# TRACKING FORM

Proposal: Noncoal Waste Storage Area Designation

Description: to allow relocation of the non-coal waste storage area at the Trail Mtn Mine.

**RE: AMENDMENT, NON-COAL WASTE STORAGE AREA AND DESIGNATION, PACIFICORP, TRAIL MOUNTAIN MINE, ACT/015/009, EMERY COUNTY, UTAH** 96H

DRAWING 1

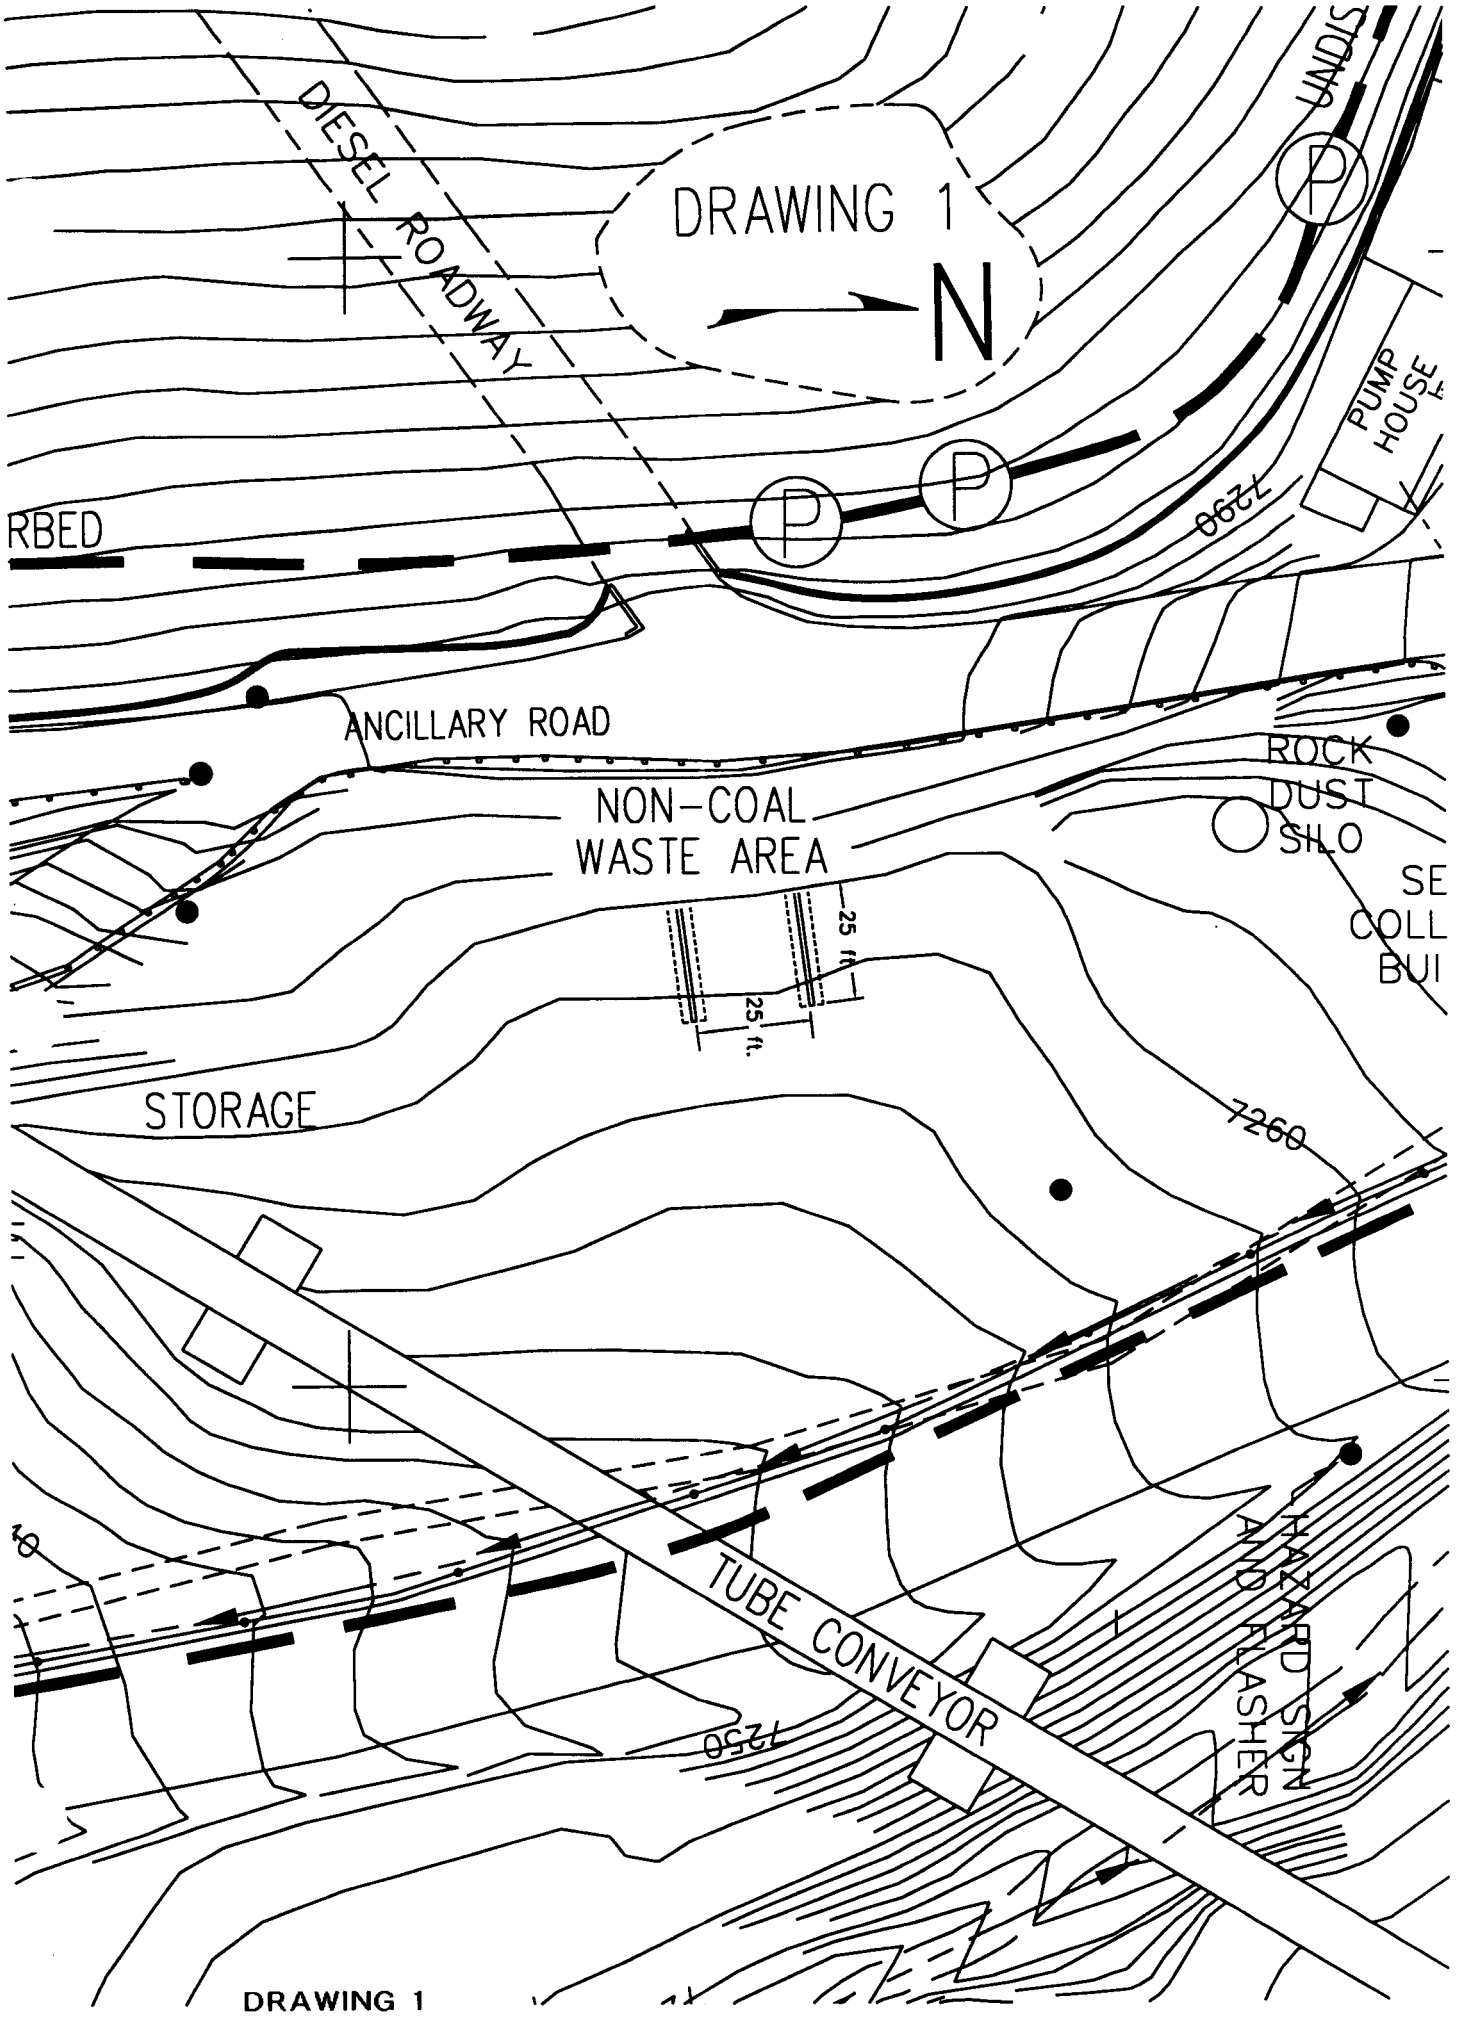
It is proposed that the mine be allowed continued use of the location as cited on the NOV 96-26-2-1, but with the intent of adding concrete wing walls, which will further define the confinement area and improve front end loading of the waste materials.

A 8 1\2" x 11" Drawing # 1, of the proposed installation and approximate location is attached for your information.

ROCK FACE
#6 DOWELS,
4 EA. WALL
48" CONV.
BELT
4" CASING
4 FT. C-C
#6 BAR, 12" C-C
#6 BAR, 12" C-C
2" X 4" KEYWAY
4 EA. #4 BAR
2 LAYERS
#6 BAR, 12" C-C
1'
8'
1'
5'
WALL SECTION
4'
25 ft.
1'
2'
2'
5'
PLAN VIEW
ENERGY WEST
MINING COMPANY
TRAIL MOUNTAIN
TRASH BUNKER
J.C.
NONE
#2
8/17/96

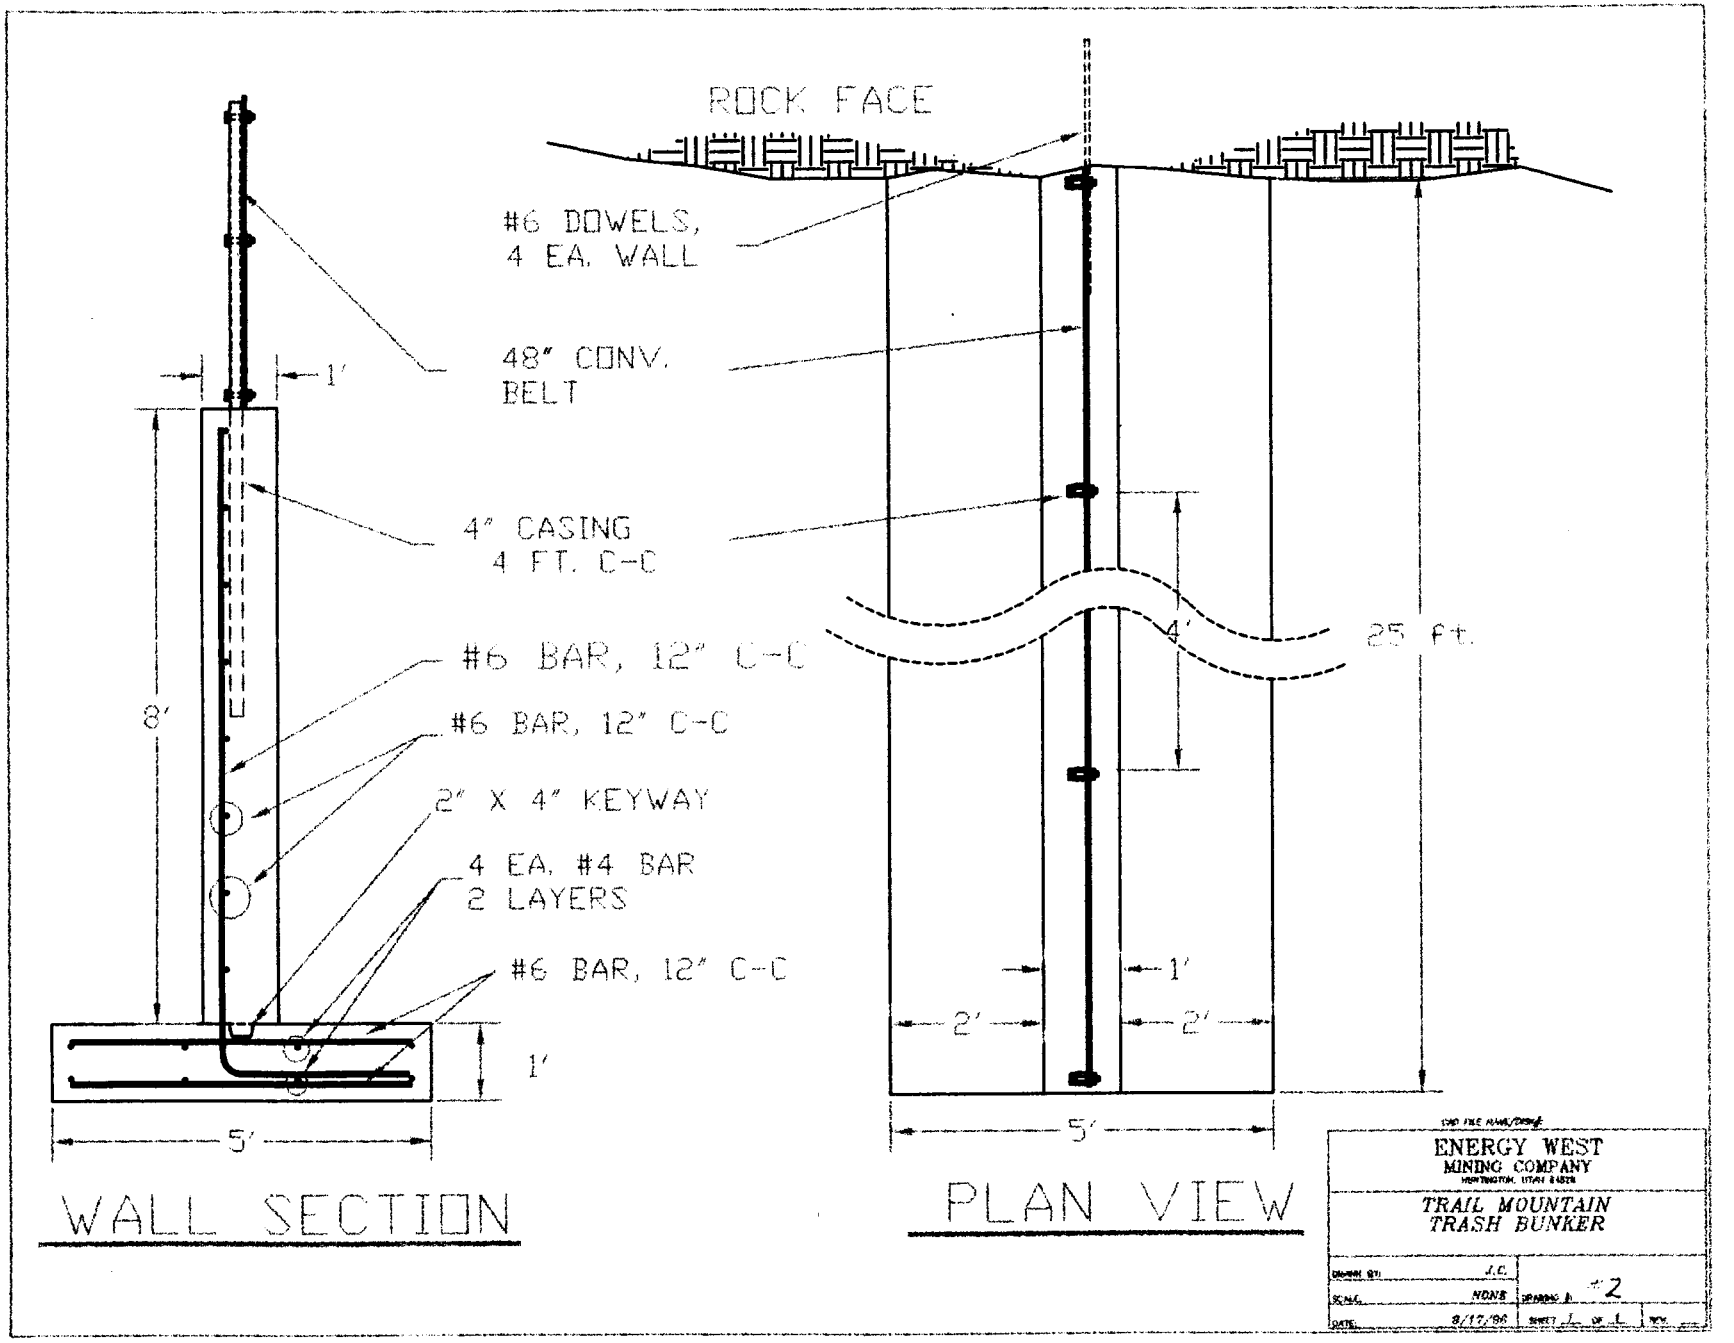
A 8 1/2" x 11" Drawing # 2, depicts the Engineering Design and structural layout of the wing walls. This drawing is for your general information.
